Request for Additional Information No. 345, Supplement 15

U. S. EPR Standard Design Certification

SRP Section: 09.02.01 - Station Service Water System

Question 09.02.01-41:

Figure 9.2.5.3—Cross-Section of UHS Tower Basin

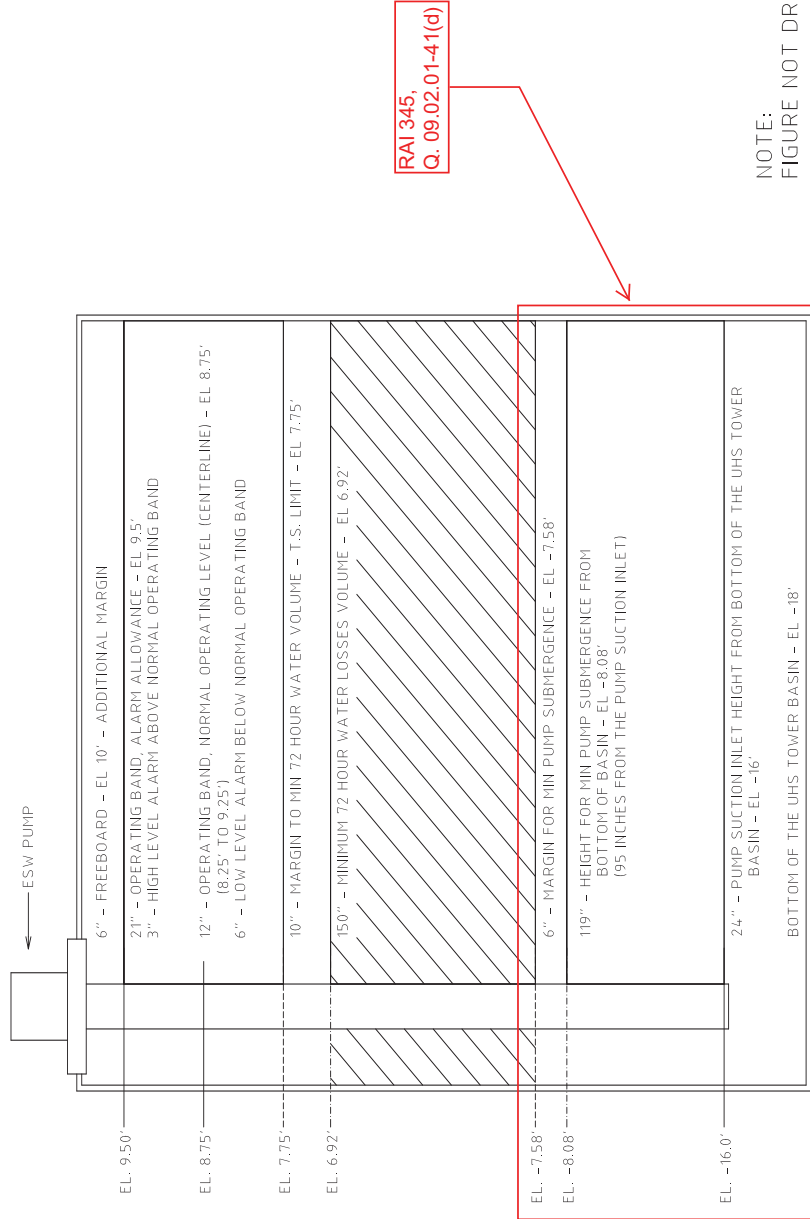
- d. The applicant should consider providing Figure 09-02-01-17-1 as a DCD figure since this is an important part of the licensing basis of the ESW pumps defining margins related to NPSH and vortexing, alarms, operating bands, related to the UHS basin.

U.S. EPR FSAR Tier 2, Section 9.2.5, was originally revised to reflect a new figure (Figure 9.2.5-3) which was based on Figure 09.02.01-17-1 that was provided in the Response to RAI 119, Supplement 2, Question 09.02.01-17. U.S. EPR FSAR Tier 2, Section 9.2.5, will be revised to reflect a revised Figure 9.2.5-3—Cross-Section of UHS Tower Basin. A basin tower height with the required margin and allowance is 28 feet from the bottom of the basin. This change has been made to provide increased basin inventory and additional margin for evaporation.

RAI 345,
Q. 09.02.01-41(d)
